Docket Item # 1
BAR CASE # 2016-0406

BAR Meeting
December 14, 2016

ISSUE: Certificate of Appropriateness – New Construction
APPLICANT: VHD LLC
LOCATION: 699 North Patrick Street
ZONE: CRMU-M

BOARD ACTION: Approved as amended, 6-0

2
26
BALCONY RAILING - TYP.
1/2" = 1'-0"
ELEVATION

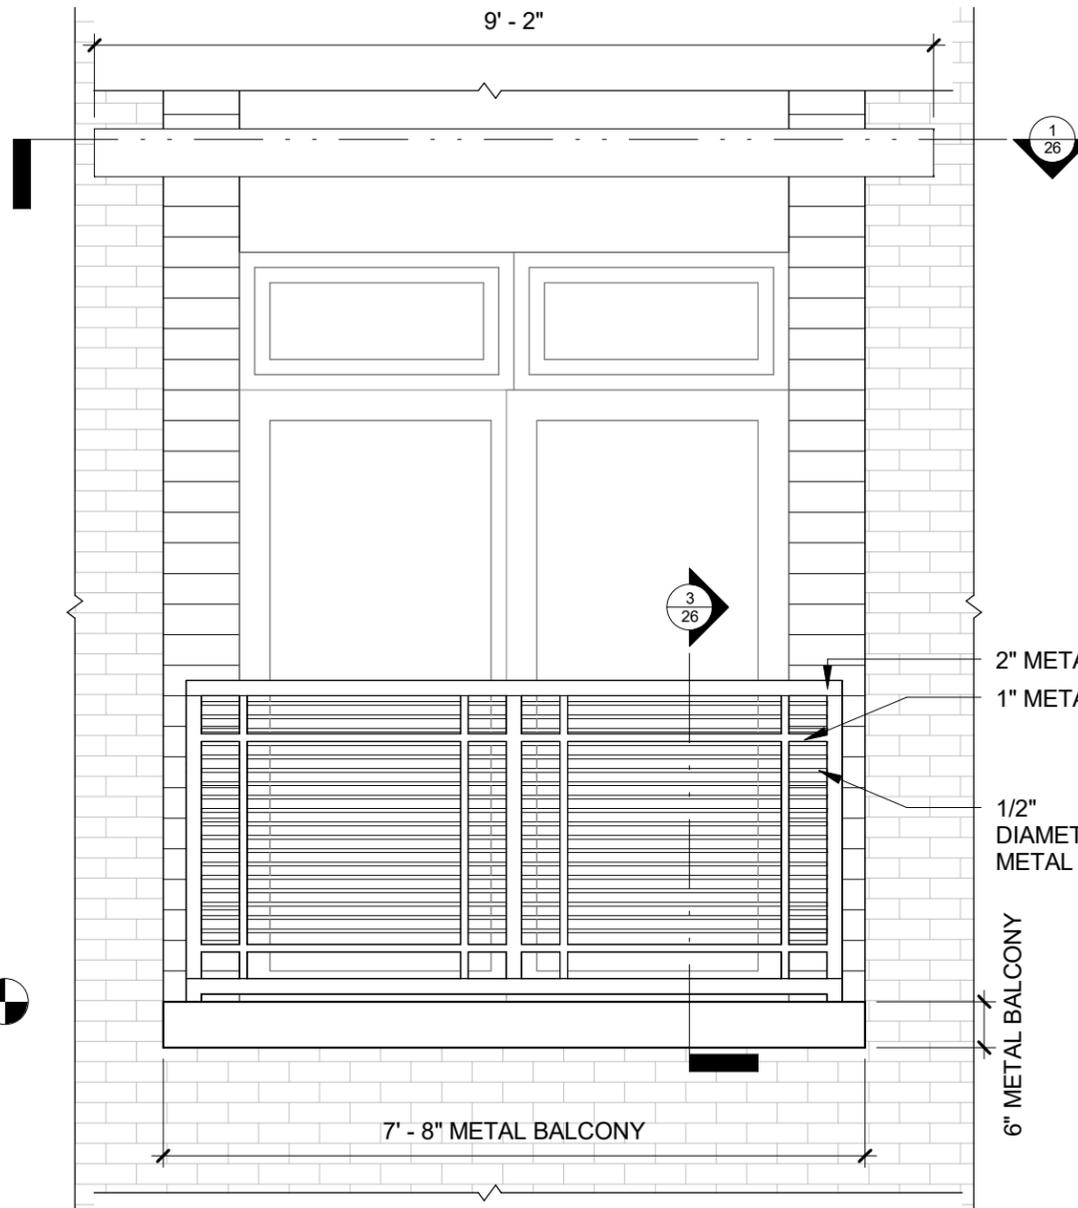
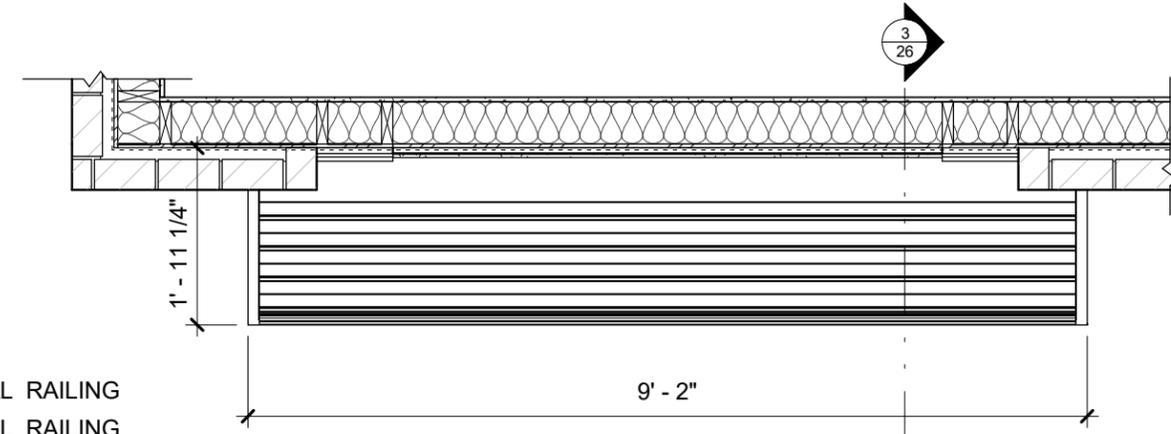
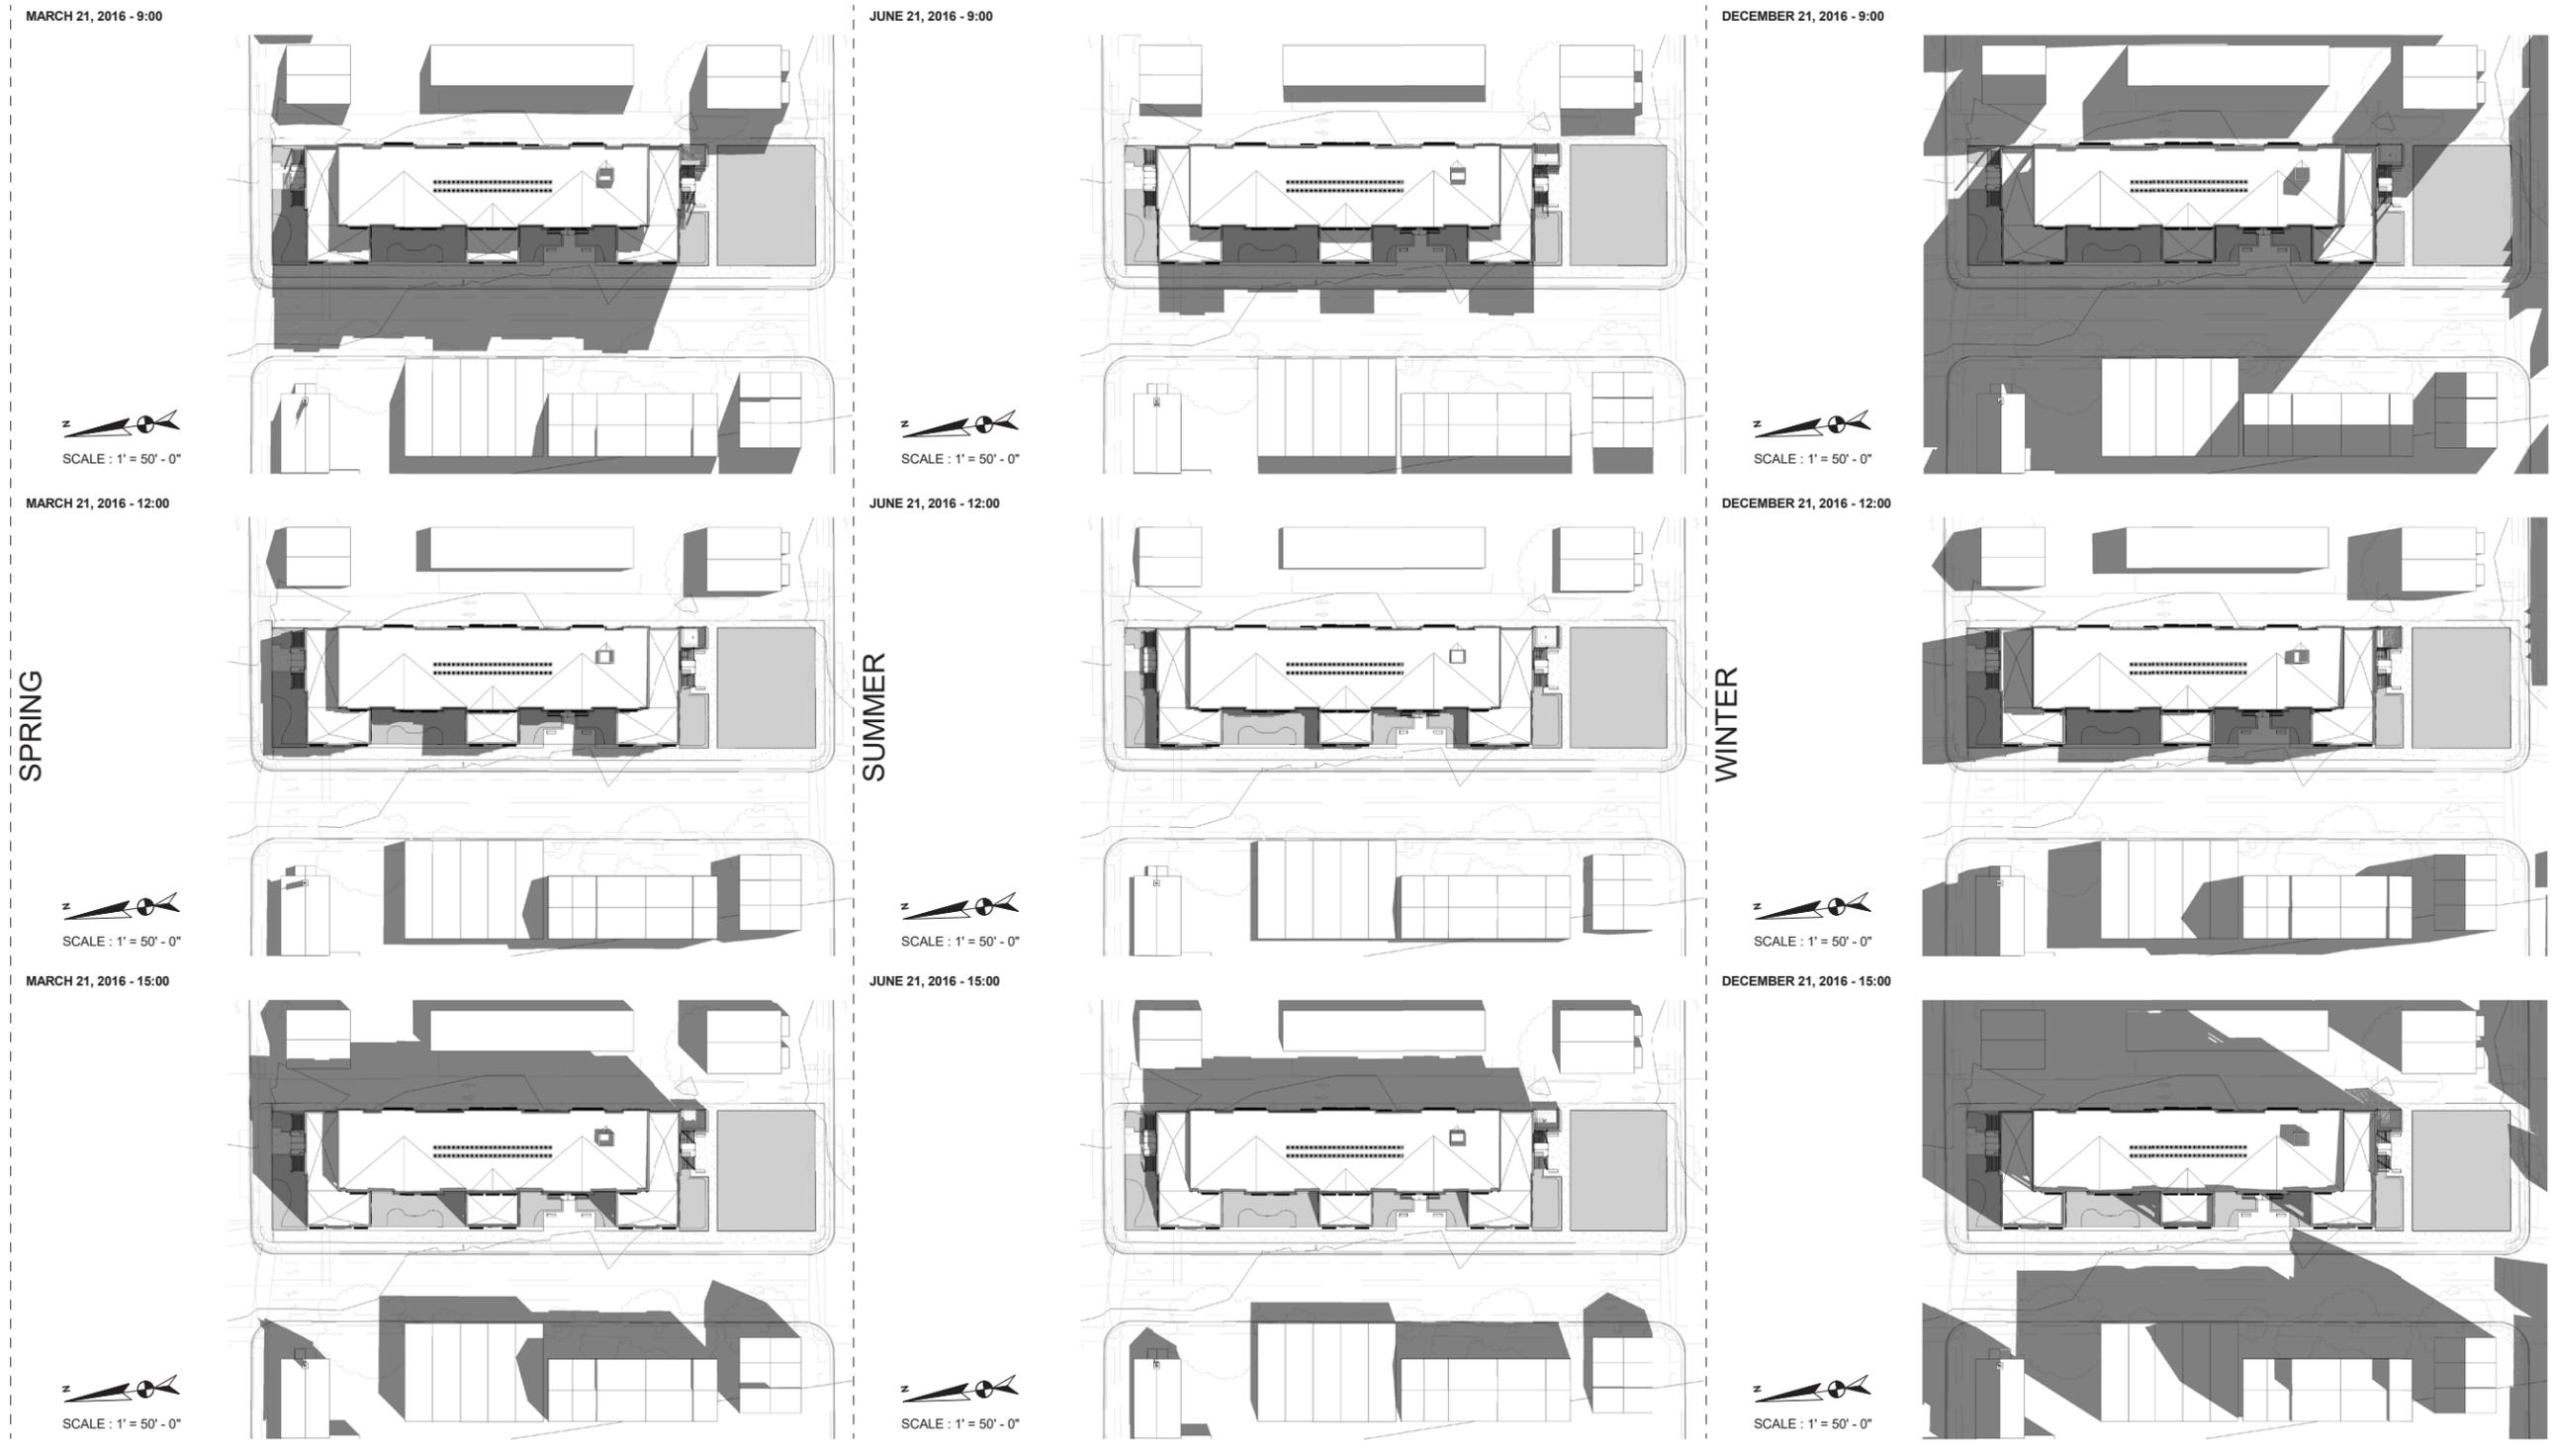
The BAR previously noted that the location of the balconies should logically reflect the interiors of the units to be most appropriate and noted that those balconies were an opportunity to contribute to the character of the building. Staff supports the simple horizontal railings and finds that they work cohesively with the "sunshades," together providing an appropriate balance to the vertical orientation of the windows. A sample of the railing should be constructed as part of the mock-up.

Comment 7: Juliet balconies should relate to the internal organization of the units wherever possible. Railings should be unique and artistic and not generic.

Response 7: Upon review of all balcony locations, KTGy has confirmed that all rooms with a Juliette balcony can be furnished such that a tenant can maintain proper clearance to operate the sliding glass doors.
